TOTAL PERFORMANCE VAN'S AIRCRAFT

SERVICE BULLETIN 13-08-29

Date Released: August 8, 2013
Date Effective: August 8, 2013
Subject: Nut Retaining Throttle Cable Lead to Throttle Arm
Affected Models: All RV-12 Powerplant Kits and flying RV-12 aircraft
Required Action: Replace Rotax locking nuts with MS21045-3
Time of Compliance: At disassembly of affected hardware or next condition inspection

FIGURE 1: VA-219 INSTALLED WITH INCORRECT M5 ROTAX NUT

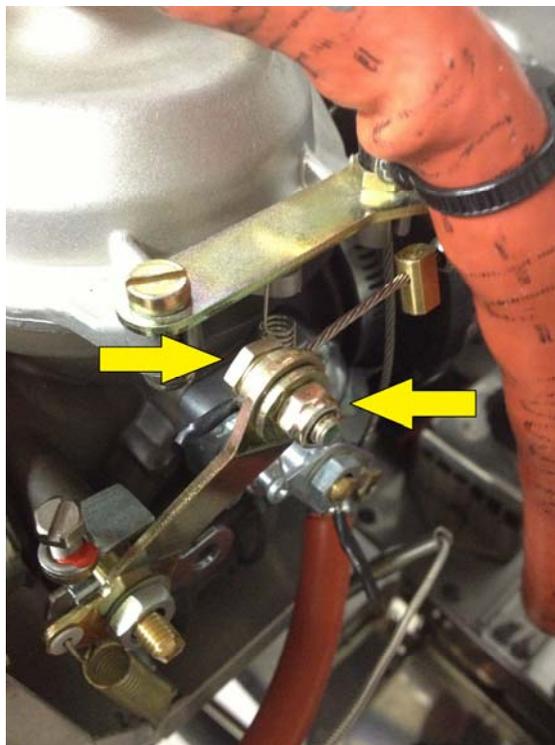
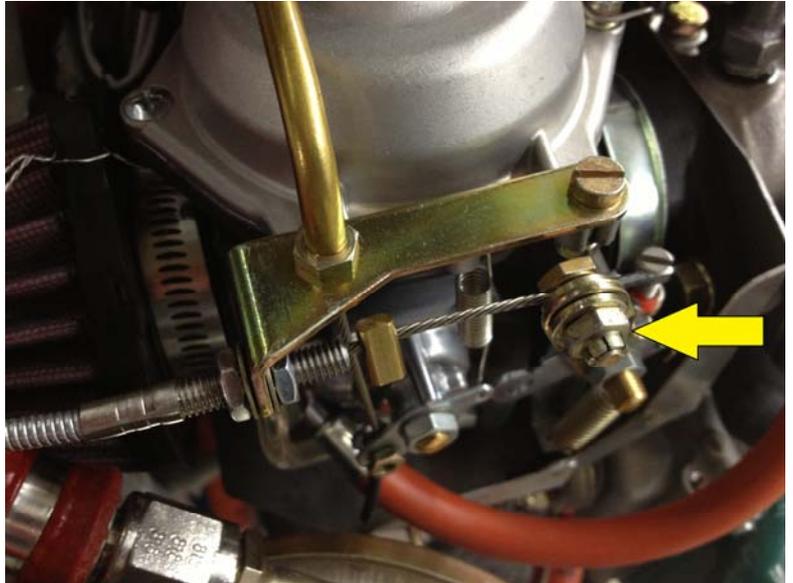
VA-219 bolt supplied uses 10-32 threads while nut specified is metric thread. A nut of compatible thread needs to be used.

Affected throttle cables were supplied with VA-219 bolts (AN3 bolt with a hole drilled in the shank). Check both the left and right throttle installations using the Figure 1 and your copy of Kit Assembly Instructions (KAI), Page 50-05.

Installations not using VA-219 and using Rotax hardware supplied with the engine are not affected.

Remove both Rotax M5 nuts.

Inspect the threads of the VA-219 bolts and replace if any damage is present.

Replace both M5 nuts with MS21045-3 nuts as shown in Figure 2.
